HISTORIC AND DESIGN REVIEW COMMISSION

February 21, 2025

HDRC CASE NO: 2025-027
ADDRESS: 210 HERMINE BLVD
LEGAL DESCRIPTION: NCB 9008 BLK 4 LOT 44 THRU 46
ZONING: R-4, H
CITY COUNCIL DIST.: 1
DISTRICT: Olmos Park Terrace Historic District
APPLICANT: Yolanda Jimenez/NEISD
OWNER: Yolanda Jimenez/BSS FINANCIAL LLC
TYPE OF WORK: Driveway and apron installation; and apron modifications
APPLICATION RECEIVED: February 07, 2025
60-DAY REVIEW: April 8, 2025
CASE MANAGER: Bryan Morales

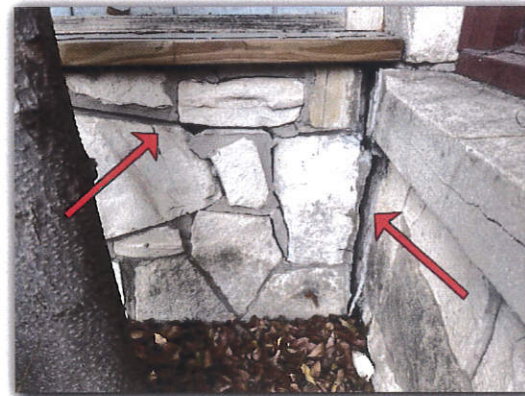
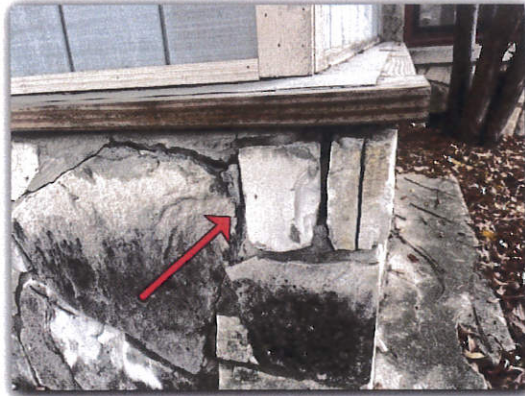
Interior:

Noted: Signs of previous repair/newer paint in places.

Noted: Cracks are visible along the sheet rock seams.

Noted: What appears to be a dead bird is present behind the stove.

1. Sheetrock/Baseboards are damaged in places.
2. Signs of structural settling or movement. Stress cracks are present.

F. Ceilings and Floors

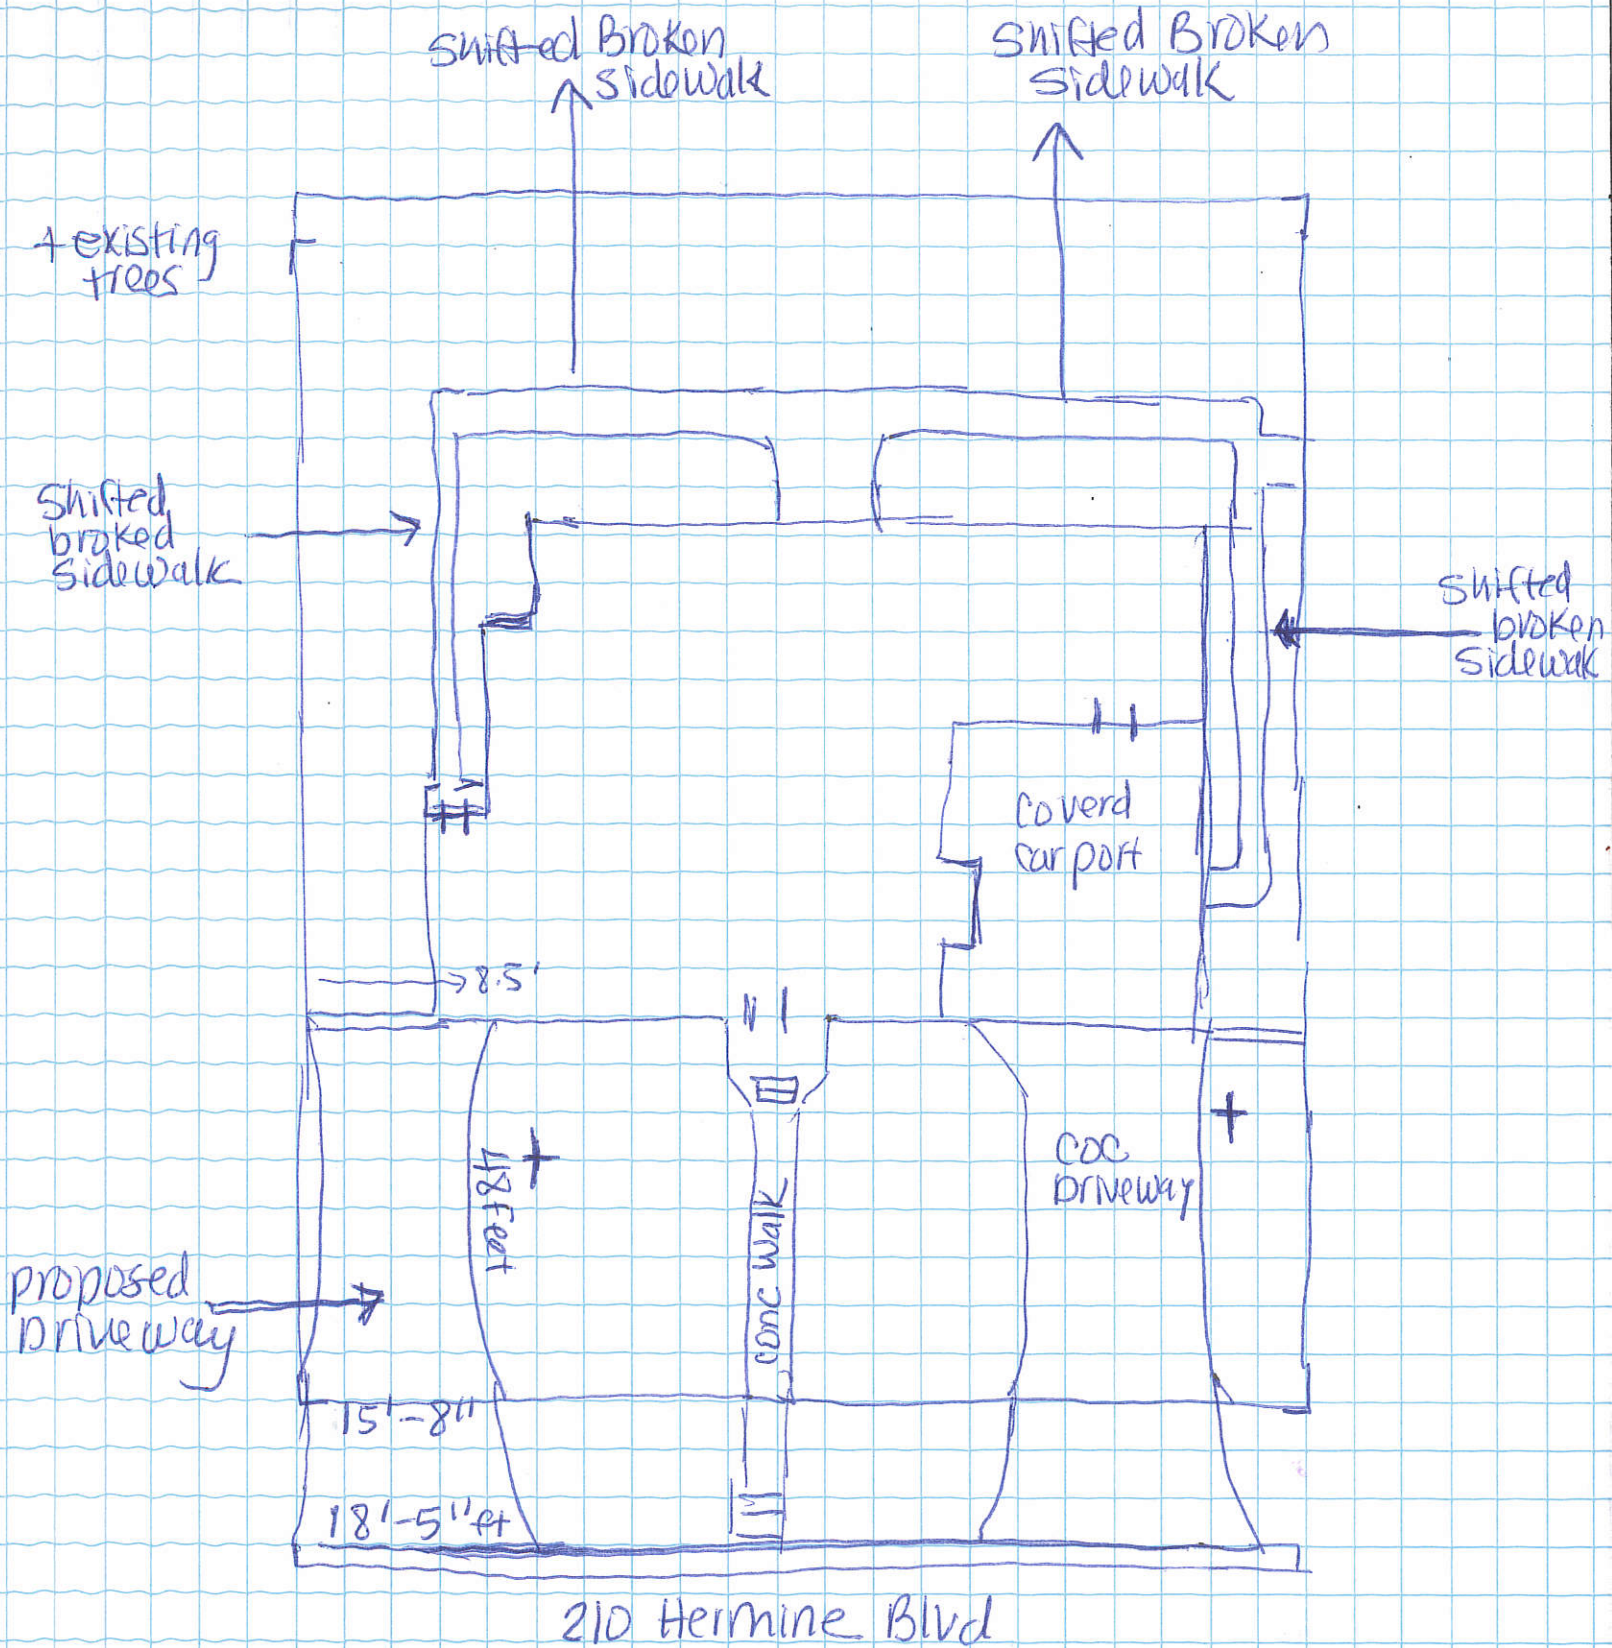
Ceiling:

Noted: Signs of previous repair/newer paint in places.

Noted: Cracks are visible along the sheet rock seams.

Floors:

1. The floor is visibly not level in one or more locations.
2. Wood flooring is damaged. Middle living room.
